LOCKWOOD GLEN
PUD SUBDIVISION
DEVELOPMENT PLAN REVISION 2
SD-R (SPECIFIC DEVELOPMENT - RESIDENTIAL)
FRANKLIN, WILLIAMSON COUNTY, TENNESSEE

LOCKWOOD GLEN DEVELOPMENT PLAN REVISION 2 COF#XXXX
PROPOSED CHANGES:
SECTION 12 - 11 RESIDENTIAL LOTS (PREVIOUSLY 79 RESIDENTIAL LOTS)
SECTION 13 - 0 RESIDENTIAL LOTS (PREVIOUSLY 2 RESIDENTIAL LOTS)
SECTION 14 - 1 RESIDENTIAL LOTS (PREVIOUSLY 6 RESIDENTIAL LOTS)
SECTION 15 - 16 UNITS (NO CHANGE; NOT INCLUDED IN DEVT PLAN REVISION)
SECTION 16 - 50 RESIDENTIAL LOTS (NEW SECTION)
SECTION 17 - 28 RESIDENTIAL LOTS (NEW SECTION)

PRE-APPLICATION SUBMITTAL: JANUARY 22, 2018
INITIAL SUBMITTAL: APRIL 9, 2018
RESUBMITTAL: MAY 3, 2018
COF# 6676

LOCKWOOD GLEN PUD SUBDIVISION
DEVELOPMENT PLAN, REVISION 2

WORKING CONCEPT
PLAN

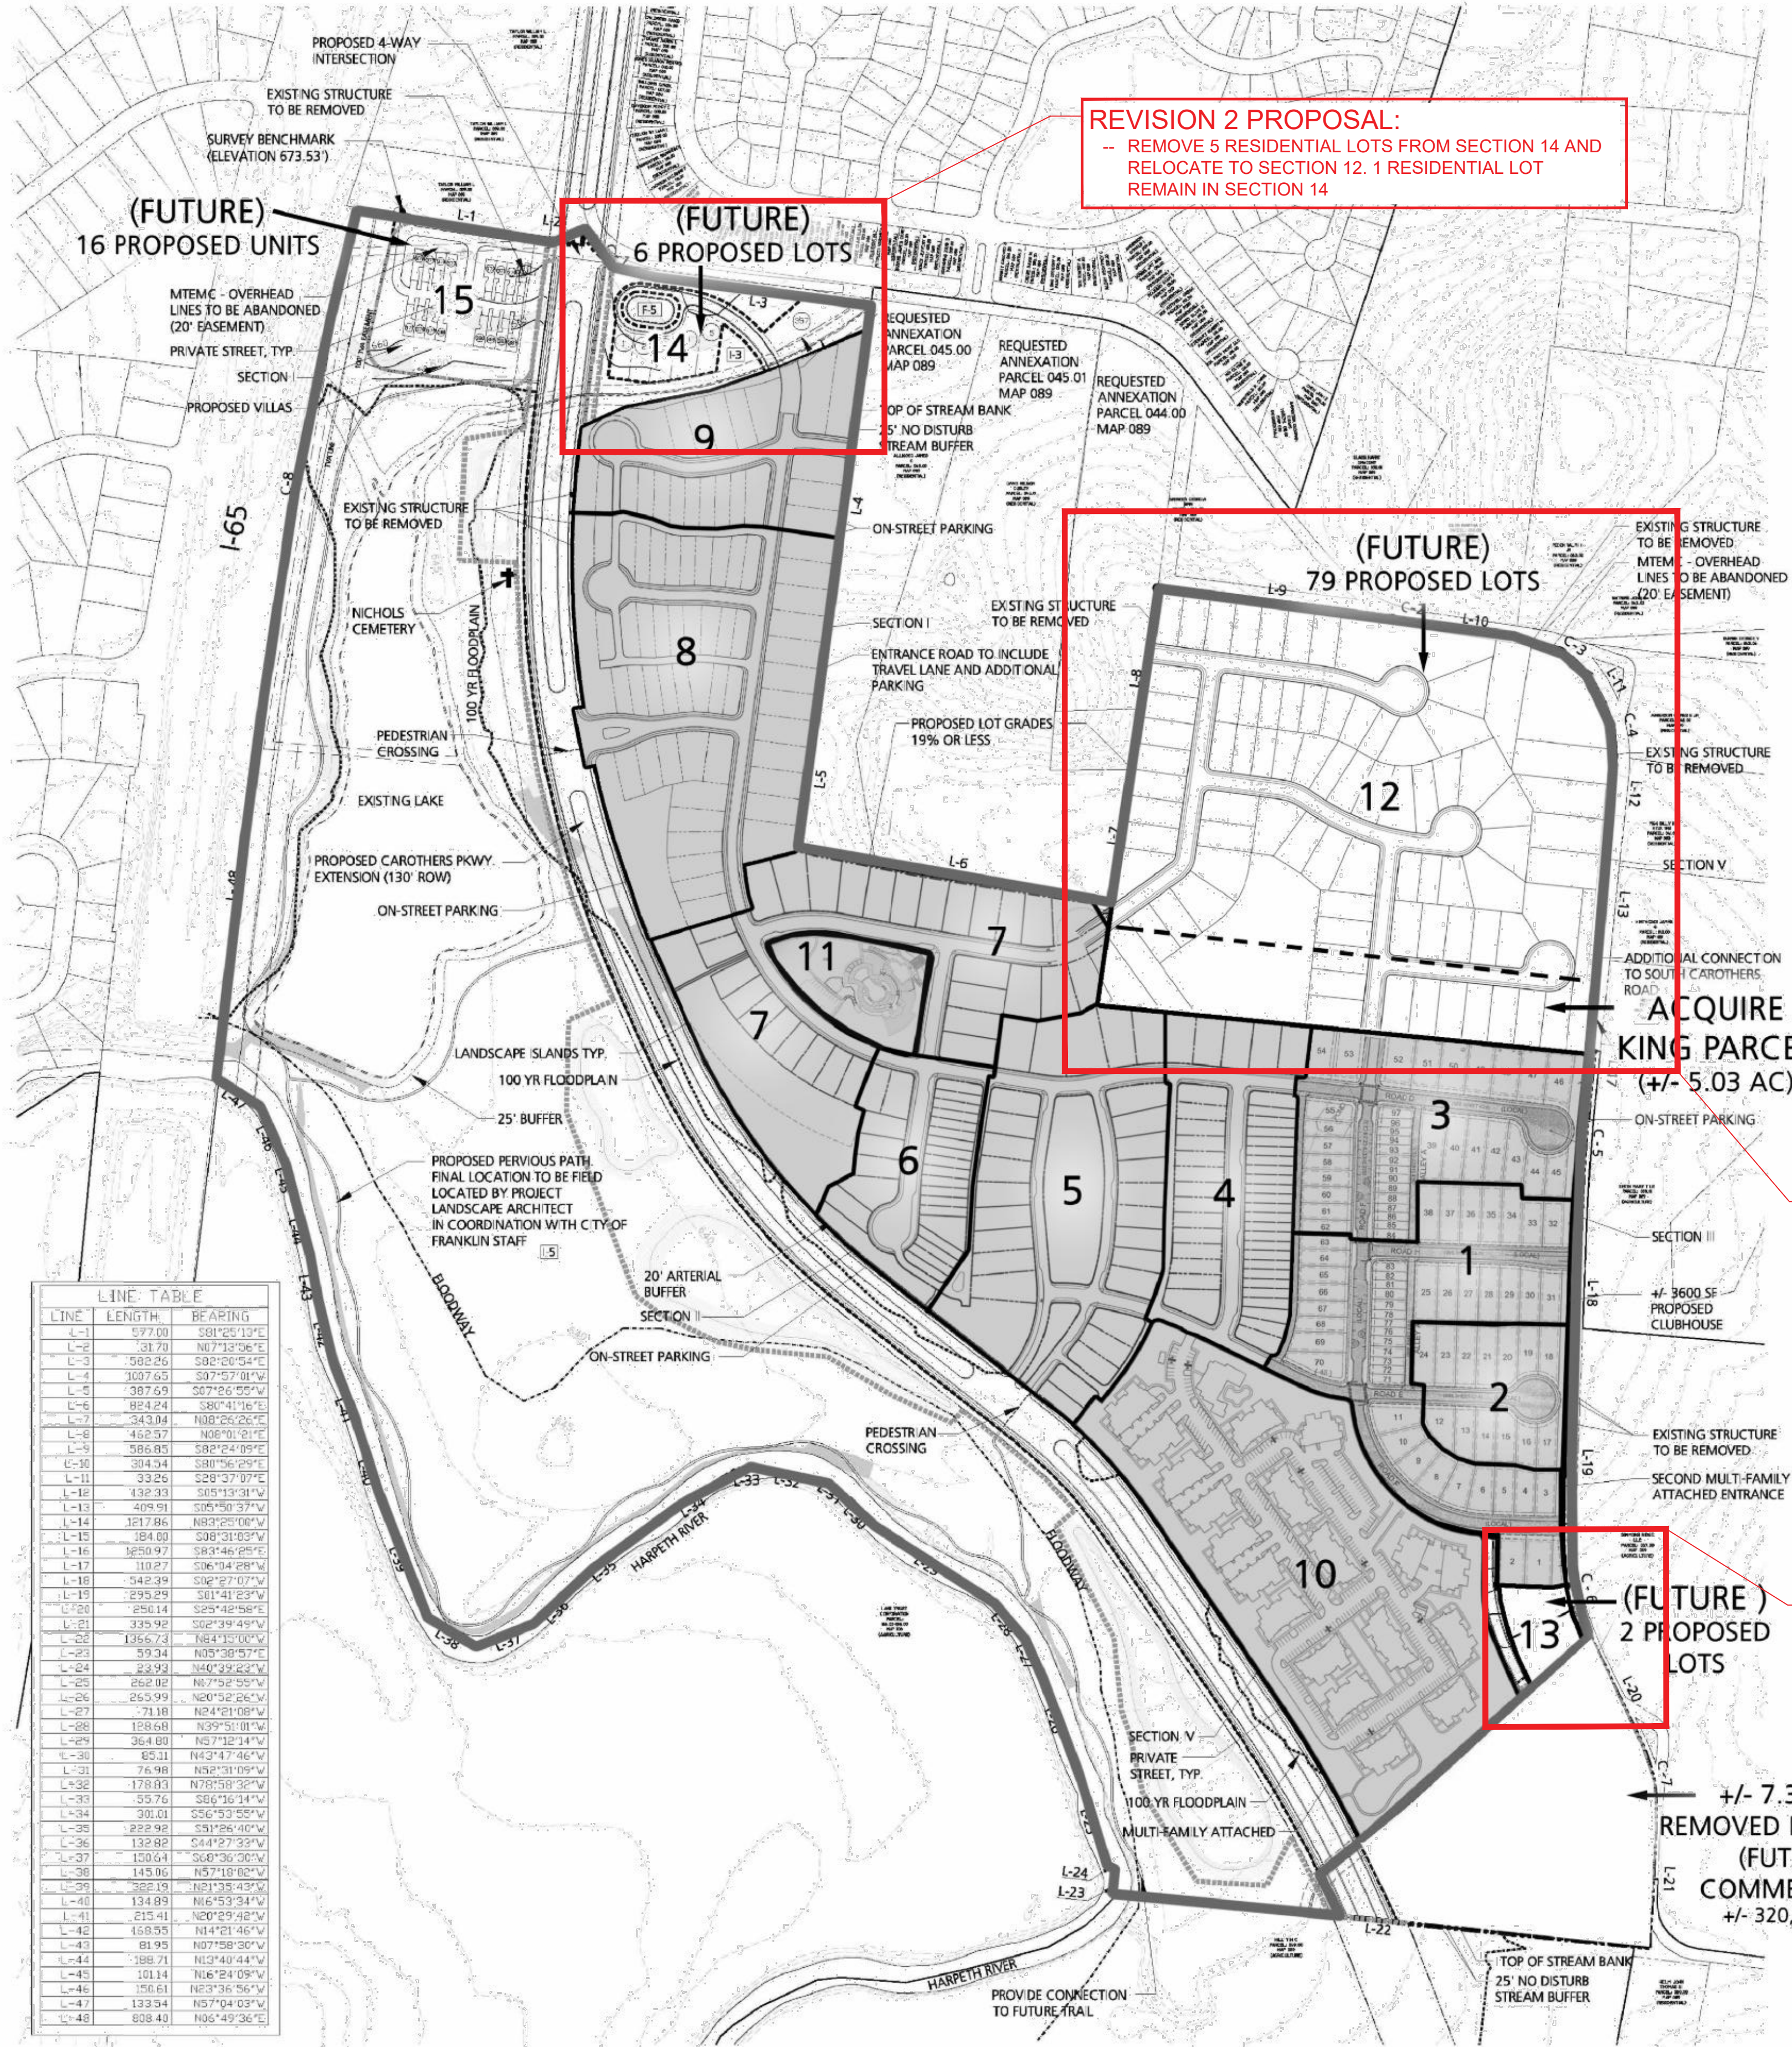
REVISION 2 PROPOSAL:
-- REMOVE 5 RESIDENTIAL LOTS FROM SECTION 14 AND RELOCATE TO SECTION 12. 1 RESIDENTIAL LOT REMAIN IN SECTION 14

REVISION 2 PROPOSAL:
- CAPTURE (1) LOTS FROM PREVIOUSLY APPROVED SECTION 13
- CAPTURE (6) LOTS FROM PREVIOUSLY APPROVED SECTION 14
- CAPTURE (3) PREVIOUSLY APPROVED LOTS

REVISION 2 PROPOSAL:
REMOVE (2) LOTS FROM SECTION 13 AND RELOCATE TO SECTION 12; NO RESIDENTIAL LOTS TO REMAIN. AREA TO REMAIN AS NON-BUILDABLE OPEN SPACE

89 TOTAL PROPOSED UNITS
-11 IN SECTION 12 (PREVIOUSLY 79)
-50 IN SECTION 16 (NEW PHASE)
-28 IN SECTION 17 (NEW PHASE)
